Engineering Bulletin: ECR00173

Systems Affected: 400SS

**Subject:** 400SS Product Enhancements

## **GLASS-TO-EDGE**

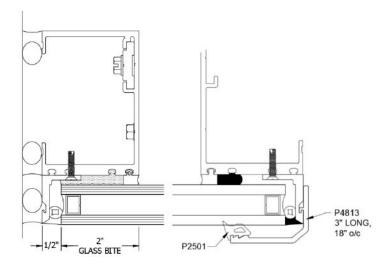
**SSG PERIMETER** - Two options: Glass-to-edge & an applied 7/8" tube.
